New Ave Bikeway Section B, City of Takoma Park Mandatory Referral, MR2021024

Staff Recommendation: Approval of Mandatory Referral with Comments

Staff recommends **approval** of the Mandatory Referral with the following comments to transmit to the City of Takoma Park:

Figure 7: New Ave Bikeway at Poplar Avenue to Conway Avenue – Proposed Modifications

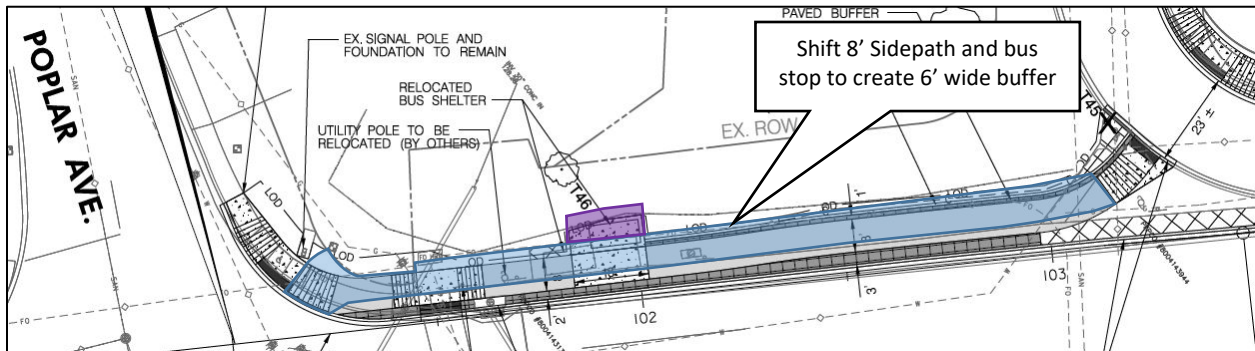
Sidepath between Poplar Avenue and Conway Avenue: This section is extremely tight with the provision of an eight-foot-wide sidepath and only a three-foot-wide buffer. This could be improved significantly by shifting the sidepath to the west (away from MD 650) to run along the edge of the right of way to allow the provision of a wider buffer (generally up to 6 feet wide). This is shown below in Figure 7.

- 3) Modify the sidepath design between Poplar Avenue and Conway Avenue by shifting the sidepath and bus stop by three feet to provide a full six-foot-wide buffer.

Figure 8: New Ave Bikeway at Conway Avenue to Prince George's Avenue – Proposed Modifications

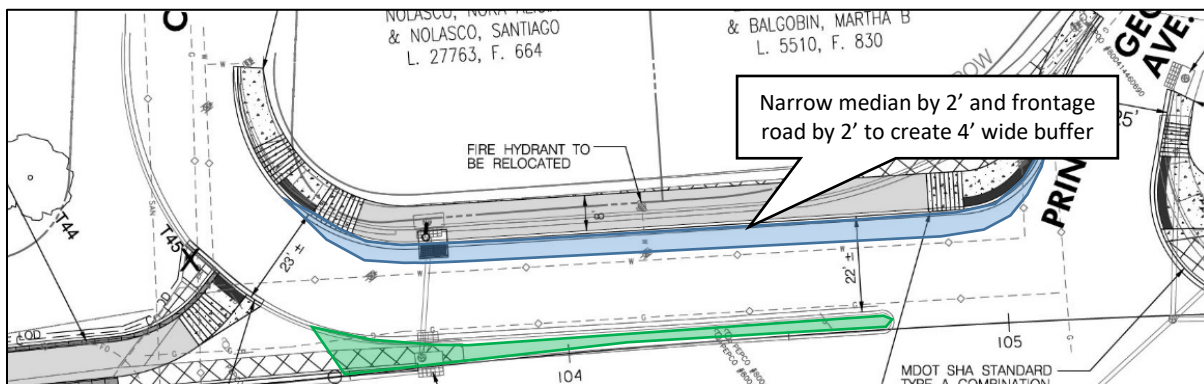
Sidepath between Conway Avenue and Prince George's Avenue: The proposed sidepath between Conway Avenue and Prince George's Avenue will be eight feet with no buffer. This is largely due to a lack of right of way and steep grades on the two adjacent residential parcels. As shown in Figure 8, a four-foot buffer could be provided with the following changes to the design:

- 4) Modify the sidepath design between Conway Avenue and Prince George's Avenue (south leg) with the following modifications:
 - a) Reduce the median between the Conway Avenue frontage road and MD 650 from four feet to a two-foot-wide concrete median,

- b) Reduce the width of the Conway Avenue frontage road from 22 feet to 20 feet, and
 - c) Relocate the curbing along the west side of the Conway Avenue frontage road to fit a four-foot-wide grass buffer between the road and the sidepath. While substandard per the Bicycle Master Plan and the Complete Streets Design Guidelines, this would be a significant improvement over the design now proposed.

1. Reduce the median between the Conway Avenue frontage road and MD 650 from four feet to a two-foot-wide concrete median (shown in green).
2. Reduce the width of the Conway Avenue frontage road from 22 feet to 20 feet.
3. Relocate the curbing along the west side of the Conway Avenue frontage road to fit a four-foot-wide grass buffer between the road and the sidepath (shown in blue). While substandard per the Bicycle Master Plan and the Complete Streets Design Guidelines, this would be a significant improvement over the design now proposed.

Figure 9: New Ave Bikeway at Prince George's Avenue to Belford Place – Proposed Modifications

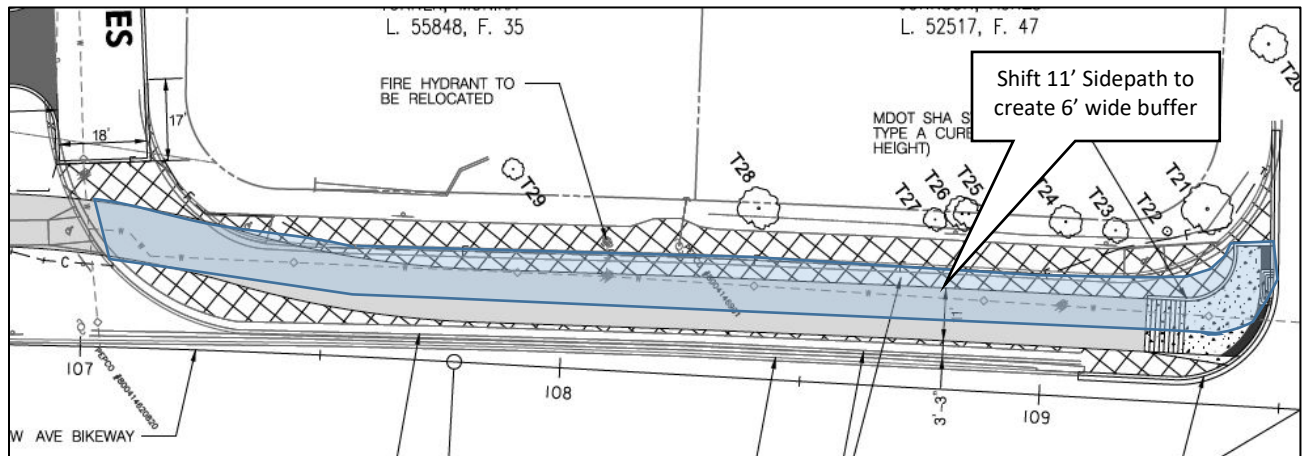
Sidepath between Prince George's Avenue and Belford Place: The closure of the existing Prince George's Avenue frontage road provides an opportunity to improve bicycle and pedestrian accommodations; however, the proposed design only provides a buffer between the sidewalk and MD 650 of 3.25 feet. Per the Bicycle Master Plan and the Complete Streets Design Guidelines, a minimum buffer of six feet should be provided. This can be done by shifting the sidepath within the existing right of way, as shown in Figure 9.

- 5) Modify the sidepath design between Prince George's Avenue (north leg) and Belward Place by shifting the sidepath to the north to provide a six-foot-wide buffer between the sidepath and MD 650.

Figure 12: New Ave Bikeway at Auburn Avenue – Proposed Design

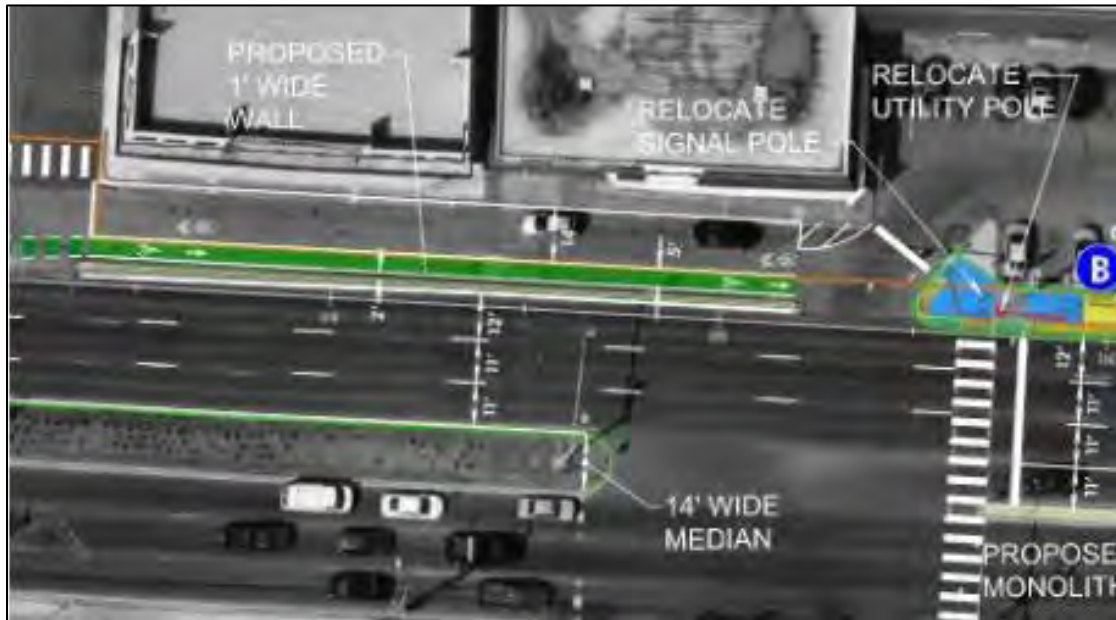
A second plan view (Figure 12) is provided in front of the New Hampshire Avenue shopping center for 225 feet from the southern property line to the existing shopping center traffic signal. The southbound sharrows/northbound contraflow bike lane concept is extended on this segment.

- 7) Modify the parking along the road edge of the New Hampshire Avenue shopping center to add curb stops to prevent vehicles from partially blocking the proposed sidepath along MD 650.
- 8) Consistent with the county's Vision Zero Action Plan efforts, eliminate the right-turn channelization and porkchop island on the Ethan Allen Avenue approach to MD 650. Furthermore, the applicant should close the southernmost driveway access to the corner parcel at this intersection.

Figure 13: New Avenue Bikeway between Belford Place and Shopping Center Signal – Option 1

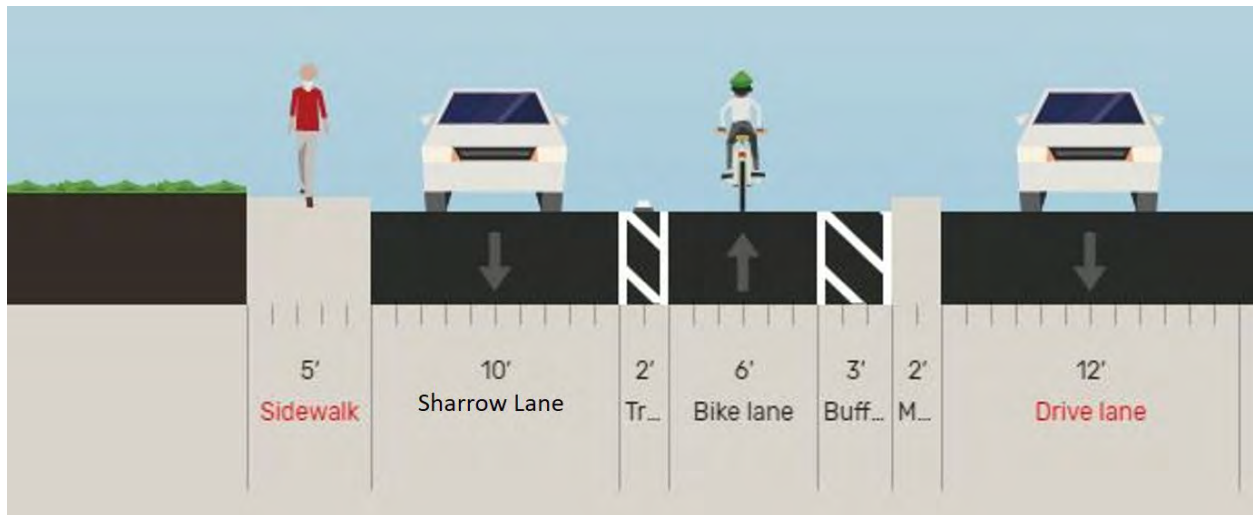
Staff does not endorse this substandard design between Belford Place and the shopping center signal; however, we recognize that preferable bikeway options are not likely to be affordable for the City of Takoma Park in the short term. The proposed design will function, but without buffers, and the Level of Traffic Stress will likely be poor. The only mitigating feature is that this frontage road has very low traffic

volumes. We recommend for consideration for the medium term, the following three options, all of which are substantially preferable to the proposed design:

Option 1: Provide driveways for the three residential parcels without driveways, and then modify the design by eliminating the seven-foot-wide on-street parking space, widening the southbound sharrow lane to 10 feet, and providing a two-foot-wide striped buffer between the contraflow bike lane and the southbound sharrow lane, and adding a three-foot-wide striped buffer between the median and the contraflow bike lane. (See Figure 13). With this option, the sidewalk will still be substandard and not ADA compliant.

Figure 16: New Ave Bikeway at Auburn Avenue – Proposed Modifications

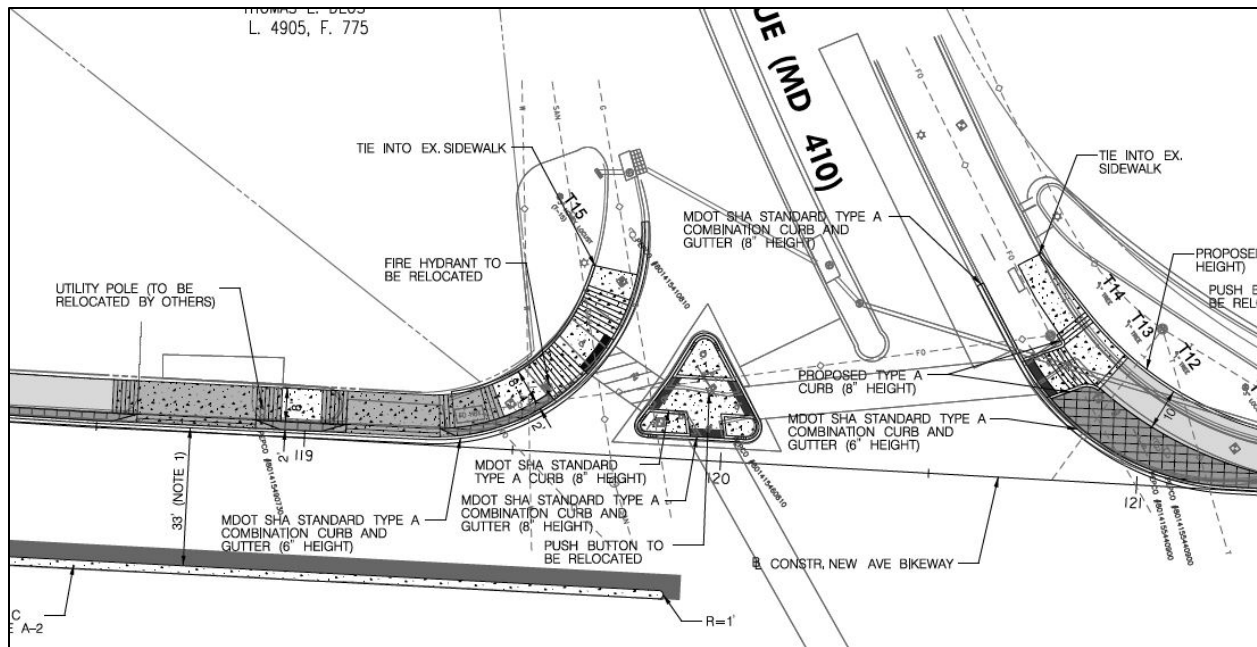
Ethan Allen Intersection and Corner Parcel Access: The proposed design has not modified the existing eastbound channelized right turn and porkchop island on the Ethan Allen Avenue (MD 410) approach to MD 650. In addition, the corner parcel (Langley Auto Sales Repair) has two access points shown to be retained. Only one access point is needed for this property, and recent observations show that the southernmost access is often blocked by parked cars. Figure 16 displays this general area on the design plans. Staff recommends that the channelized right turn and porkchop island be removed and that the southernmost driveway access to the corner parcel be closed. Since both roads at this intersection are state roads, the applicant should engage the State Highway Administration to discuss these recommended changes.
